Access Compliance Report Public Rights-of-Way (Curb Ramps)

Main Street: N/A Cross Street: IRVINE_AVE Location: S

ADA ID: RPRK211018123146 Ramp Type: Type 6 - Directional 1 Initial Pass/Fail: Pass Overall Compliance: No Severity Score: 4

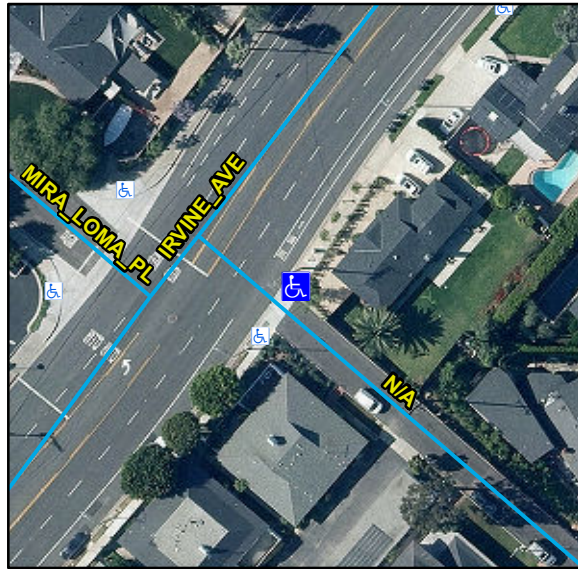
Compliance	Description	Data	Compliance	Description	Data
N/A	Ramp Length (in)	112	N/A	Flare Type LT	
Yes	Ramp Width (in)	78			Sloped
Yes	Ramp Run Slope (%)	5.6	N/A	Flare Slope LT (%)	4.9
Yes	Ramp Cross Slope (%)	2.1	N/A	Flare Traversable LT	No
No	Grade Break	No	Yes	Flare Type RT	
N/A	Grade Break Slope (%)	N/A			Curbed2
N/A	Grade Break Cross Slope (%)	N/A	N/A	Flare Slope RT (%)	N/A
	Addl Para Ramp Left?	No	N/A	Flare Traversable RT	N/A
	Addl Para Ramp Right?	No	Yes	DWS Provided	Yes
N/A	Landing Present	Yes	Yes	DWS Contrast	Yes
No	Landing Length (in)	39	Yes	DWS Length (in)	36
Yes	Landing Width (in)	48	Yes	DWS Full Width	Yes
Yes	Landing Run Slope (%)	1.3		DWS Offset Type	Single
Yes	Landing Cross Slope (%)	3.9	Yes	DWS Left Offset (in)	1
N/A	Landing Movement Obstructed?	No	N/A	DWS Right Offset (in)	2
	Landing Movement Type	N/A			
N/A	Landing Shared	No			
N/A	Marked Crosswalk 1	No	N/A	Clear Space	N/A
	Crossing 1 Direction	SW	N/A	Clear Space To Crosswalk (in)	N/A

N/A	Marked Crosswalk 1 Width (in)	N/A			
N/A	Ramp Inside Crosswalk 1	N/A			
	Crossing 1 Slope (%)	2.9			
	Crossing 1 Cross Slope (%)	4.8			
Yes	Gutter Ponding	No	Yes	Curb Slope	1.3
Yes	Gutter Lip Height (in)	0		Road Run Slope (%)	N/A
Yes	Gutter Run Slope (%)	4		Road Cross Slope (%)	N/A
Yes	Gutter Cross Slope (%)	3.3		Parallel Ramp Side	Right
Yes	Overall Surface Condition	Acceptable	Yes	Perp Joint Present	Yes
	Cross Gutter Present?	Yes		Spandrel Present?	Yes
	Replace Cross Gutter?	No		Replace Spandrel?	No

Remove & Replace Entire Ramp.

R304.2.1, R304.5.2, STD 1115
